Administrative Hearing: October 11, 2021

PlanetScale Living, Project Development Plan – PDP200015

Summary of Request

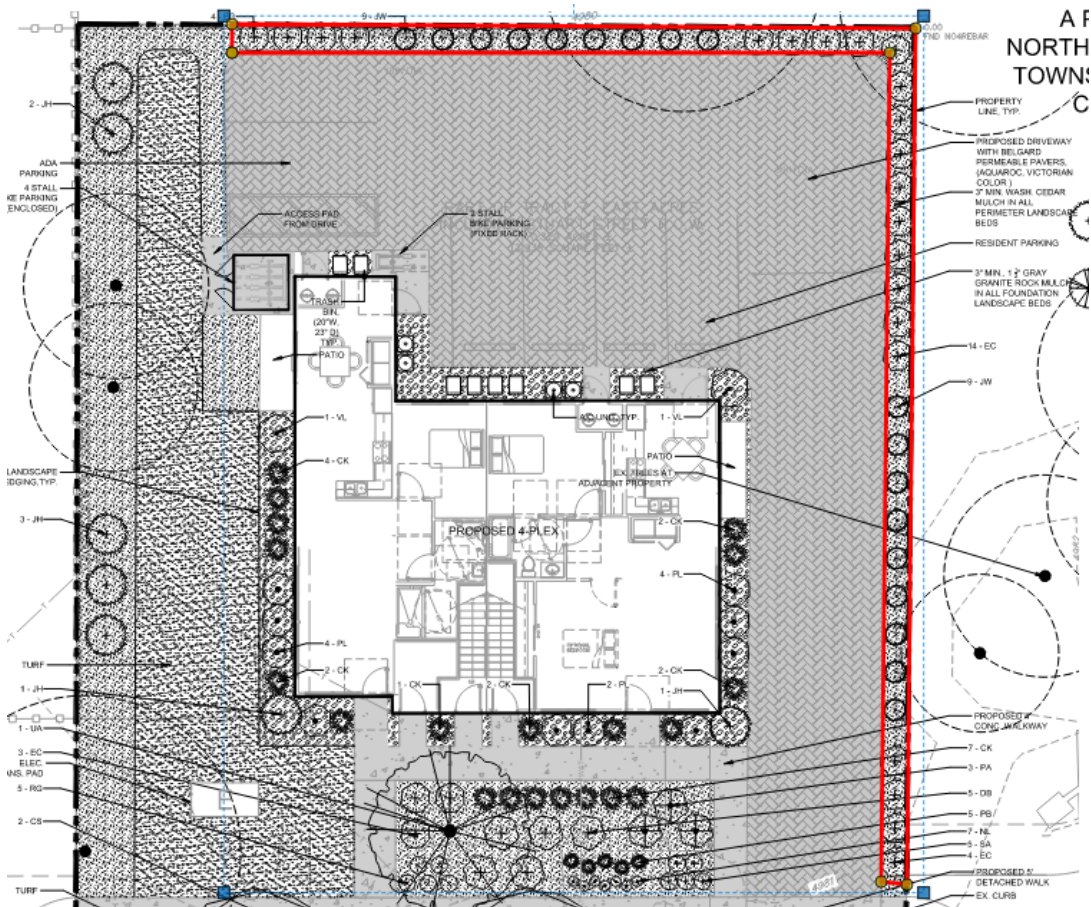
The proposed modification of standard would allow for the setback along the north and east portions of the vehicles use area to be reduced from the minimum requirement of 5 feet to 3 feet as depicted below.

- The applicant explains that the reduction by 2 feet still provides enough space to accommodate enough shrubs to provide 70%-100% screening from adjacent properties and therefore, *lacks detriment to the public good*.
- The applicant contends that the re-use of the building creates *exceptional physical conditions* that requires a balance between landscaping and room for parking behind the building.

The landscape setback areas provide a design that provides similar opacity in screening from the adjacent properties equally well as a 5 foot landscape area would and that the reduced dimensions reflect a carefully balanced set of tradeoffs reusing the existing building, setback dimensions and the overall parking lot configuration.

- An existing 6-foot picket fence that will remain along the northern property line for screening purposes;
- A combination of 40 shrubs that consist of 18 Woodward Juniper and 22 Compact Burning Bush depicted below which at maturity will create a hedgerow between the properties adjacent to the vehicle use area; and fit within the 3-foot space.
- Use of plant species (Woodward Juniper) that will provide year-round screening.

Staff recommends approval of the Modification of Standard.
